STATE OF NORTH CAROLINA
DEPARTMENT OF TRANSPORTATION

SUBJECT: **Permit Modification Request for TIP I-2511CB**, I-85 Improvements from North of SR 1002 to North of SR 2120 Near the Town of Spencer in Rowan County, State Project No. 8.1631503, Tip No. I-2511CB. Debit \$475 for Major WQC modification from WBS Element No. 34163.1.1.

REFERENCE: Individual Permit issued October 7, 2004; USACE Action ID 200221534 NC WQC No. 3456 issued April 20, 2004 (Modified January 7, 2005); DWQ Project No. 040271.

Site 1, Sheet 4 of 35

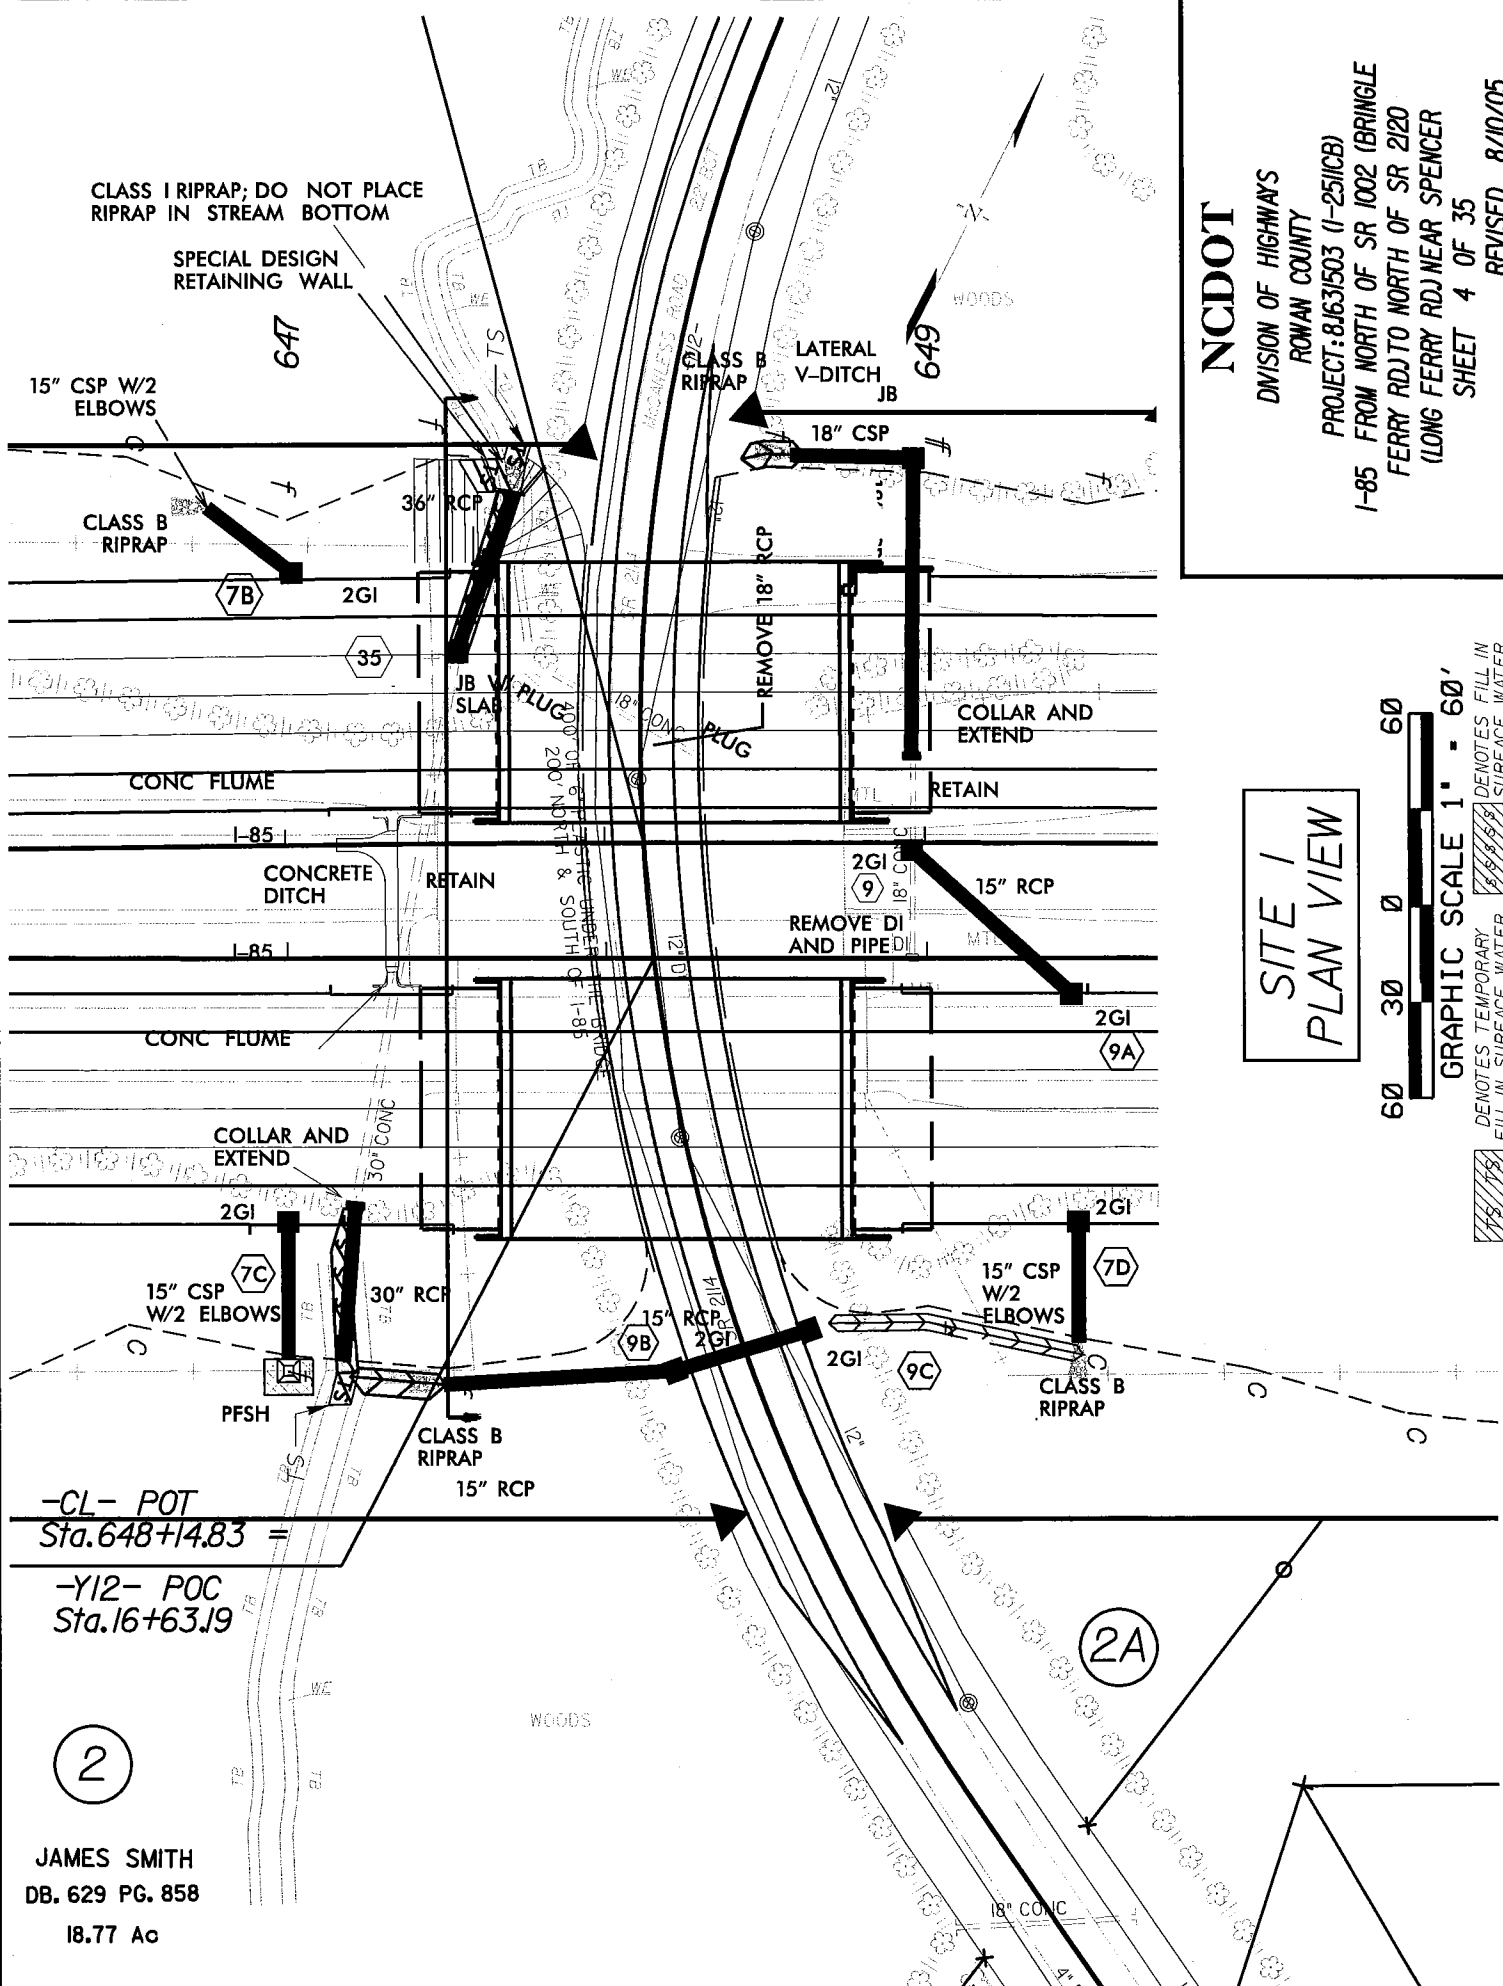
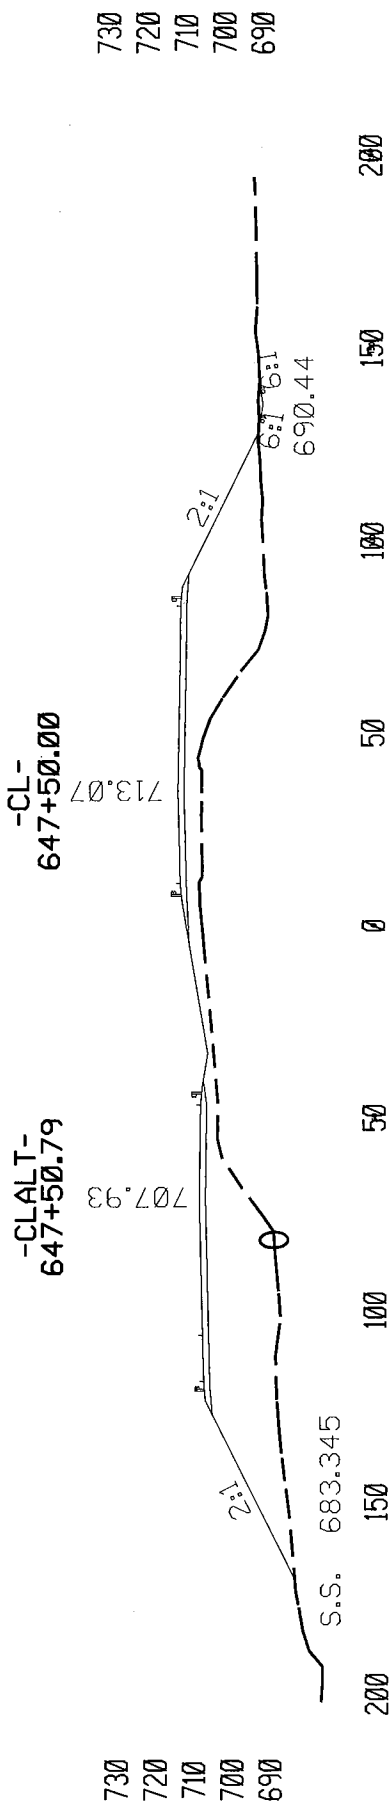
The design for the southbound lane of I-85 was shifted to the west to facilitate the construction of the southbound bridge, which resulted in an increase in permanent stream impacts. The design modification is proposed in order to maintain traffic during construction of the new bridge, allow for faster construction, and to reduce bridge construction costs. Retain and extend existing RCP in UT to Town Creek. Original Permanent Impact: 66 linear feet; New Permanent Impact: 102 linear feet.

Impact change: Permanent stream impact = increase of 36 linear feet (which requires mitigation)
Temporary stream impact = 30 linear feet

Site 2, Sheet 6 of 35

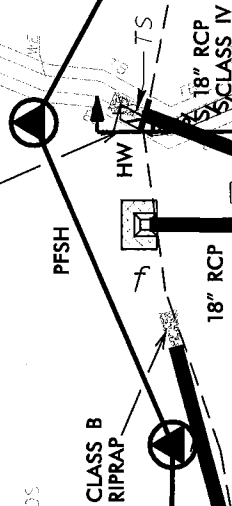
Retain and extend existing RCP in UT to Town Creek. Original Permanent Impact: 180 linear feet; New Permanent Impact: 163 linear feet.

Impact change: Permanent stream impact = decrease of 17 linear feet (originally required mitigation)
Temporary stream impact = 20 linear feet

Site 3, Sheet 8 of 35

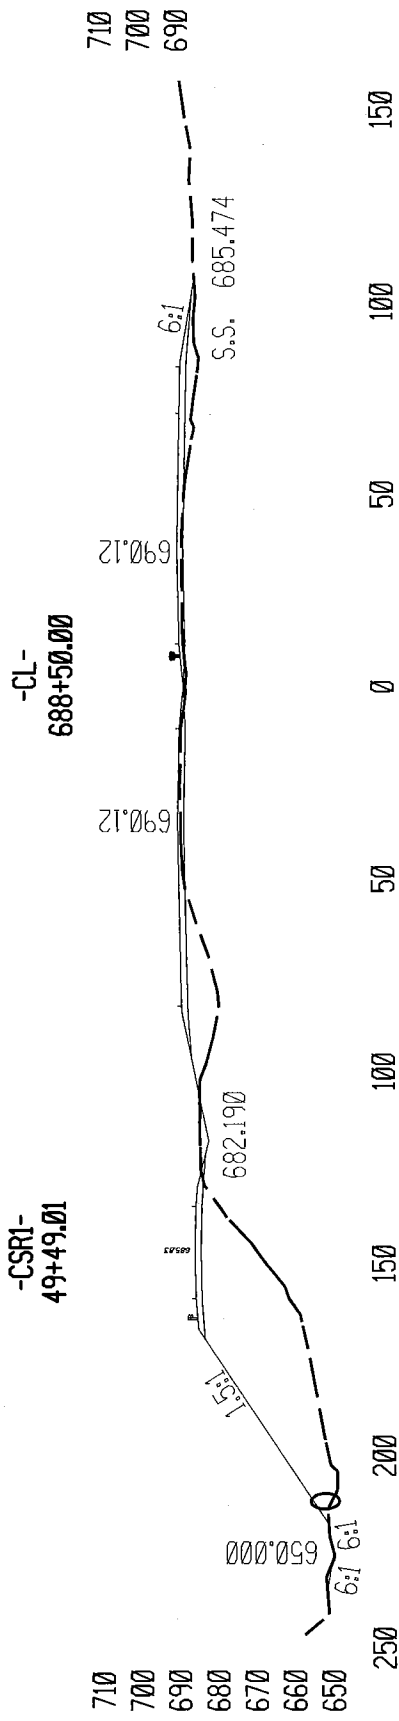
Retain and extend existing RCP in an intermittent UT to Town Creek. Original Permanent Impact: 93 linear feet; New Permanent Impact: 80 linear feet.

Impact change: Permanent stream impact = decrease of 13 linear feet (no change in mitigation requirements)
Temporary stream impact = 10 linear feet

Site 5, Sheets 12 through 20 of 35

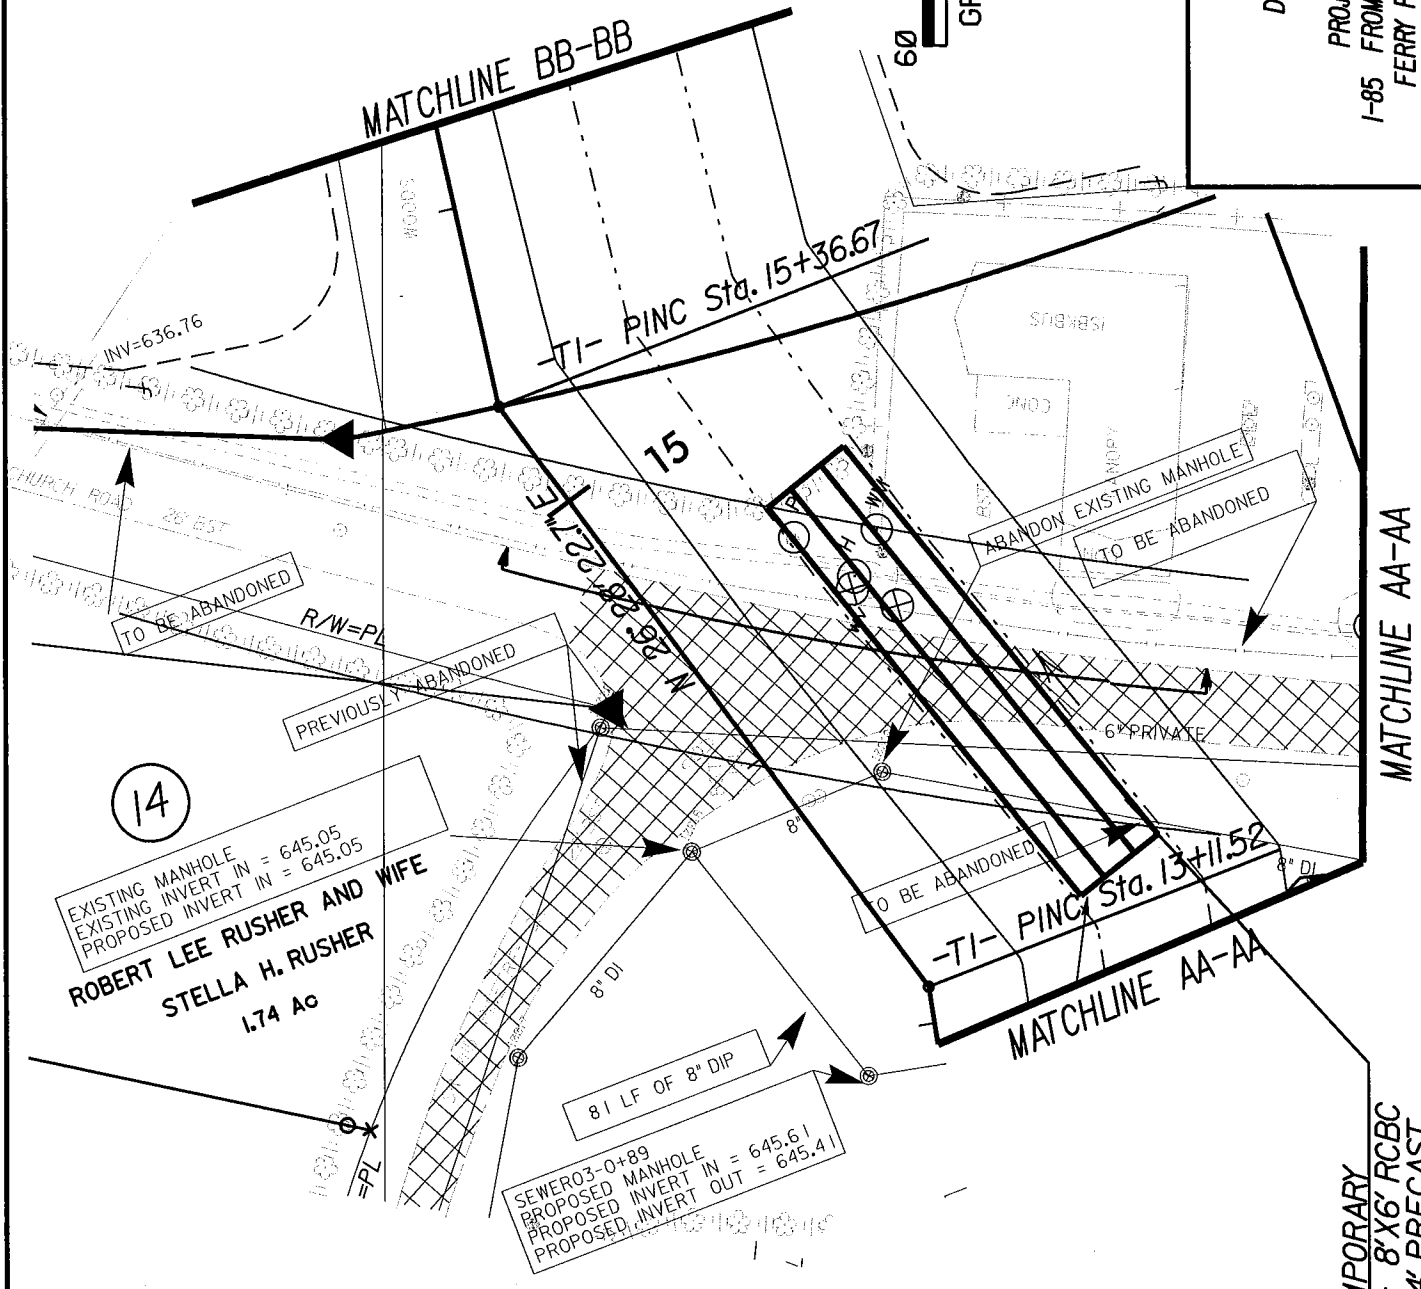
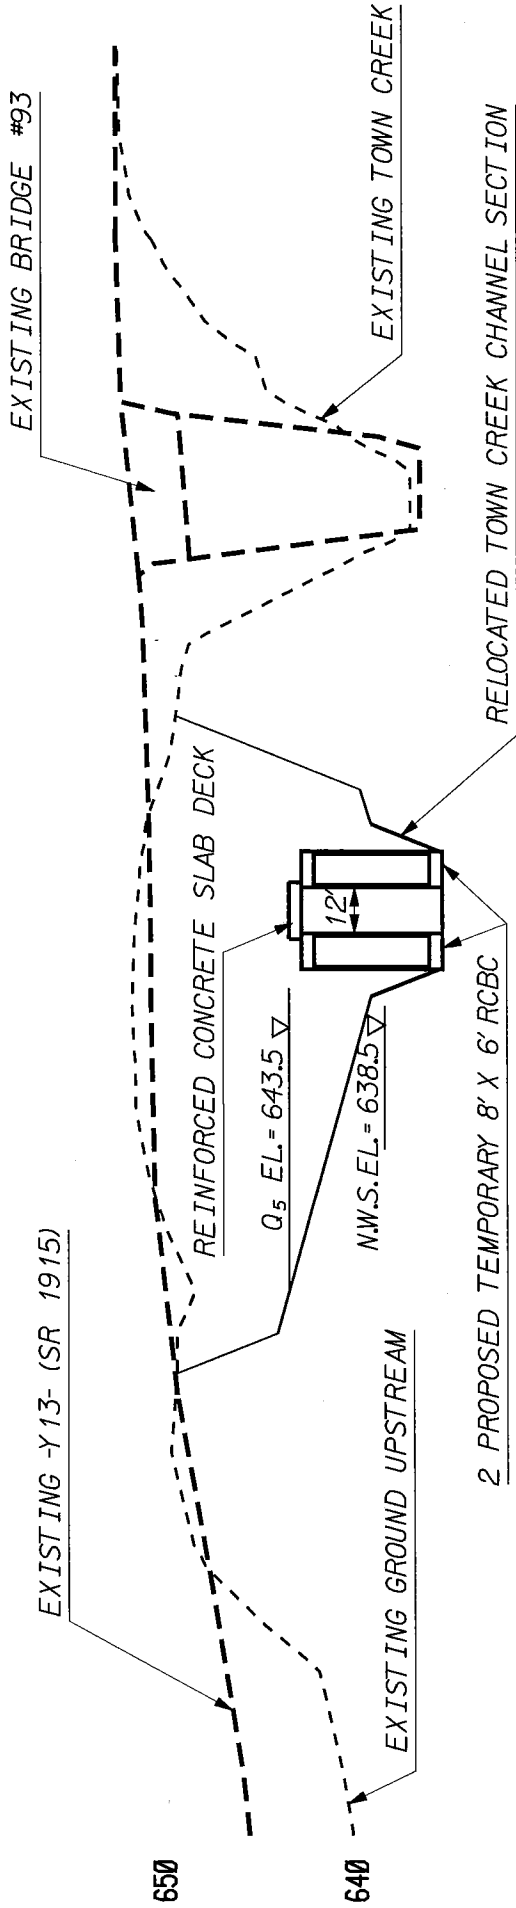
Placement of clean fill material in Town Creek. Original Permanent Impact: 864 linear feet; New Permanent Impact: 864 linear feet.

Impact change: Permanent stream impact = no change

Site 6, Sheet 21 of 35

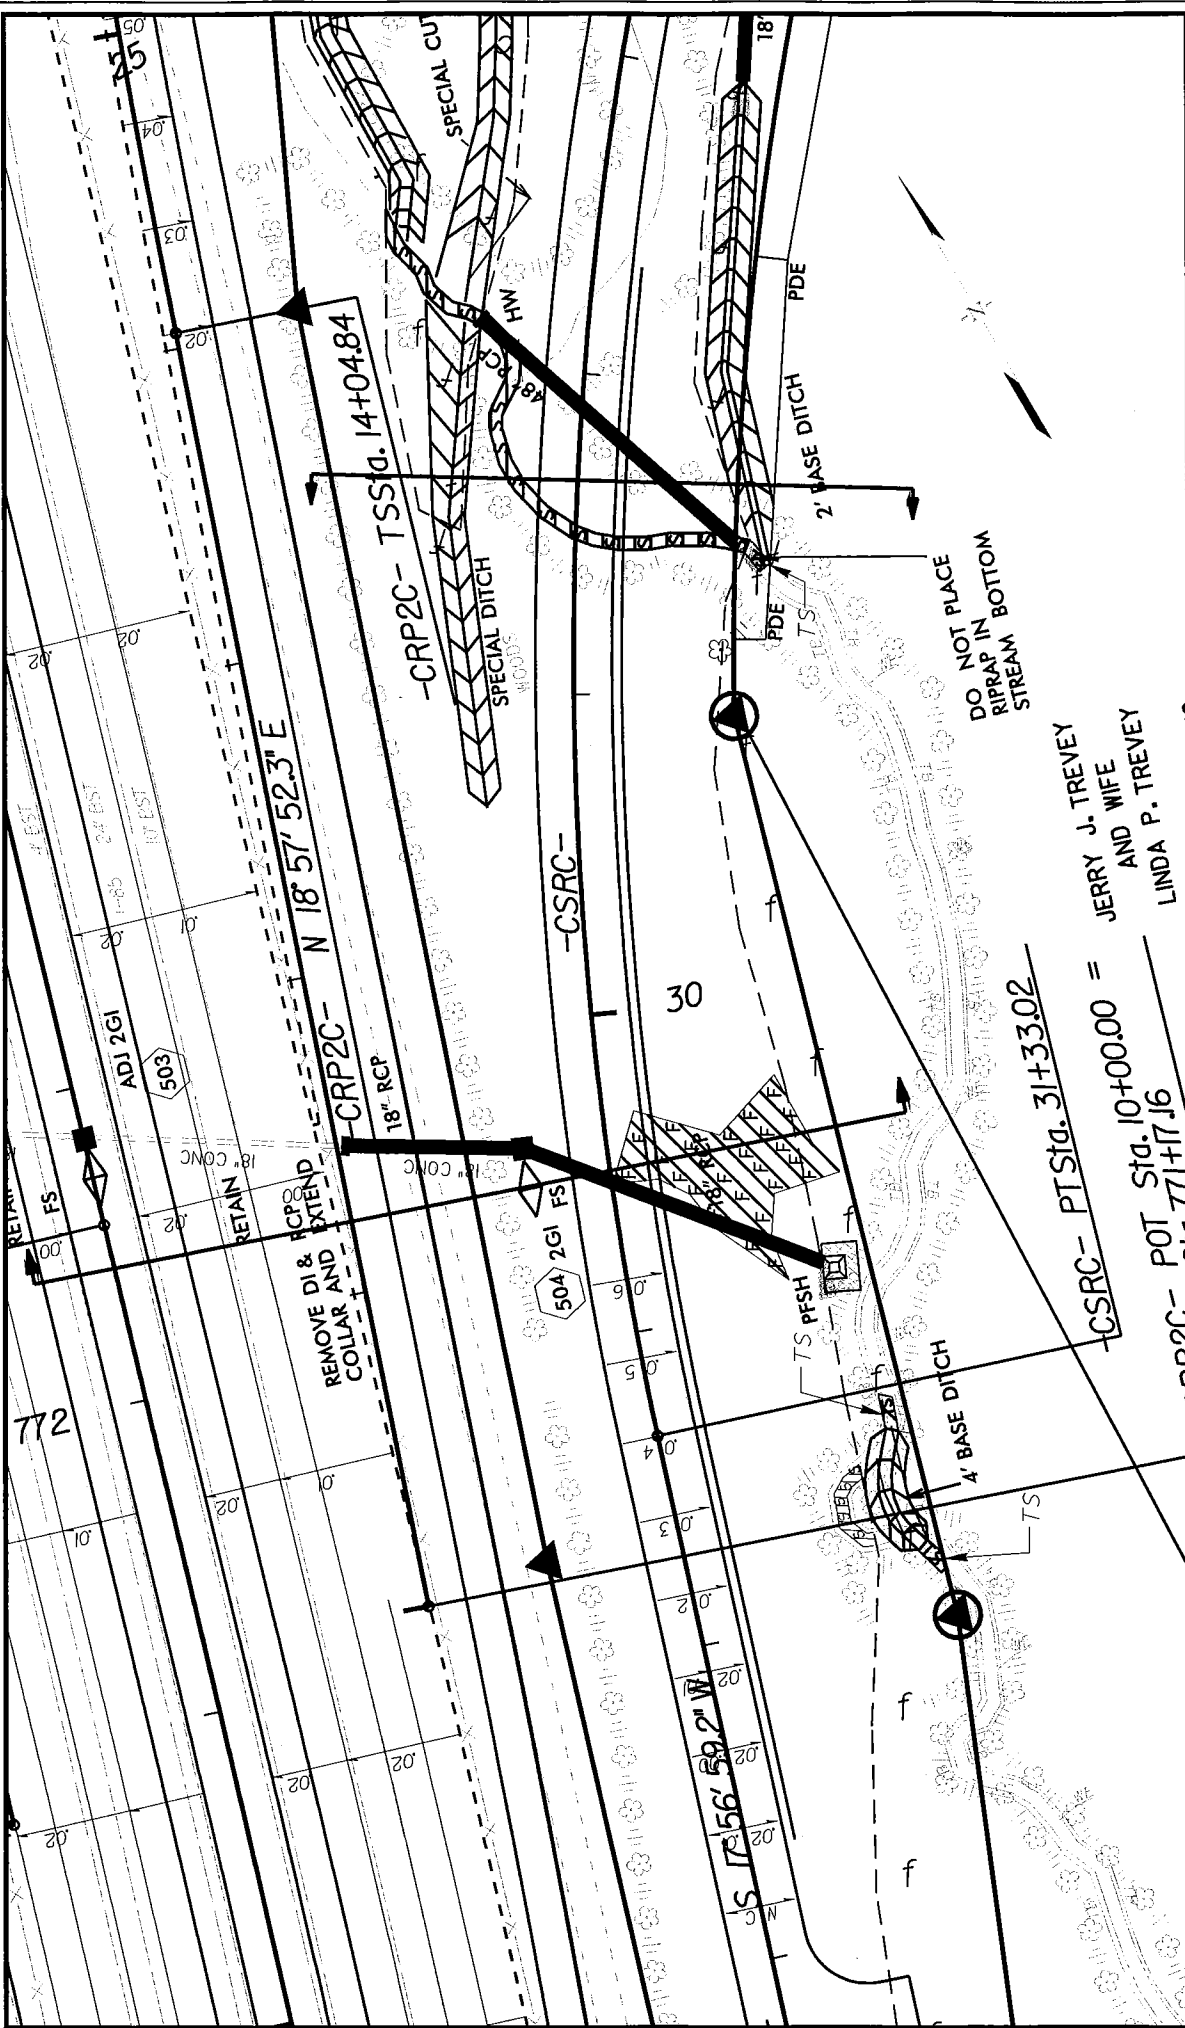
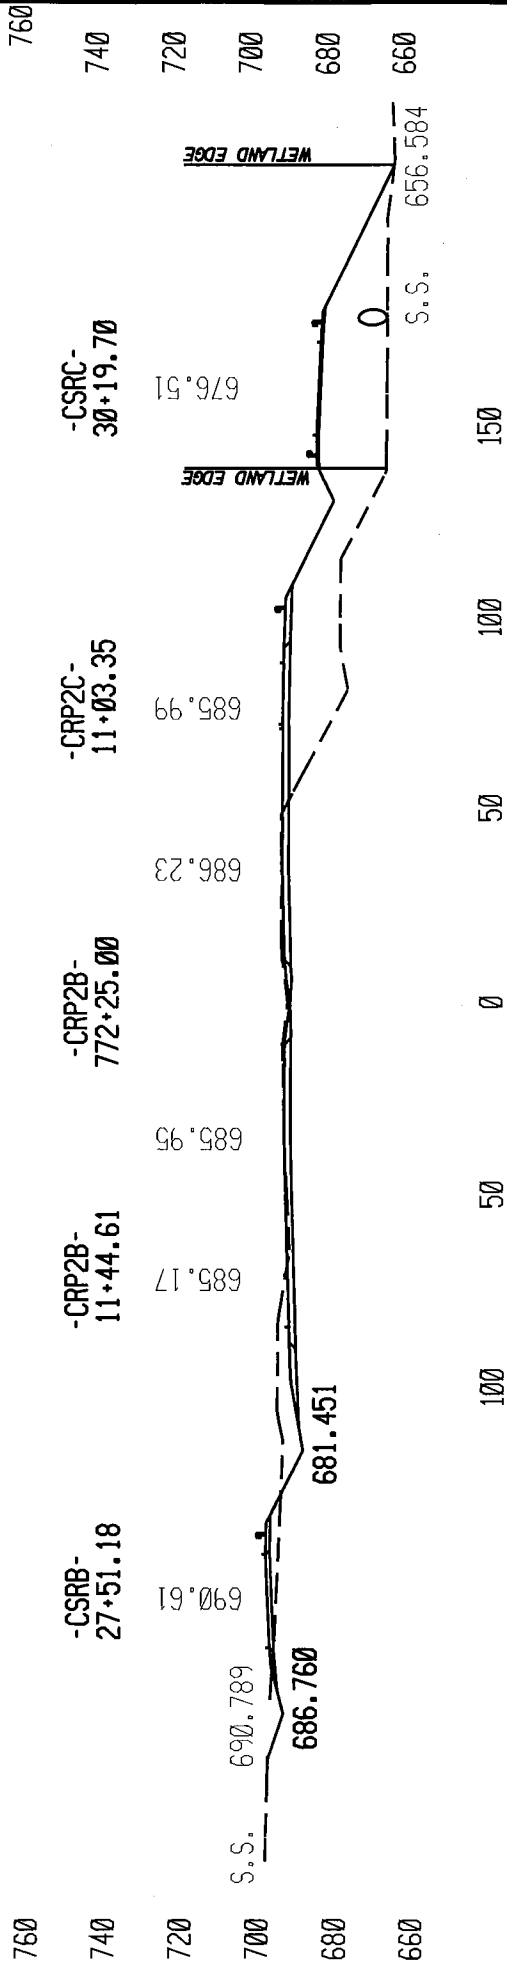
Placement of RCP in UT to Town Creek, placement of clean fill material in riverine wetland. Original Permanent Stream Impact: 200 linear feet; New Permanent Stream Impact: 200 linear feet. Original Permanent Wetland Impact: 0.047-acre; New Permanent Wetland Impact: 0.047-acre.

Impact change: Permanent stream impact = no change
Temporary stream impact = 30 linear feet
Permanent wetland impact = no change
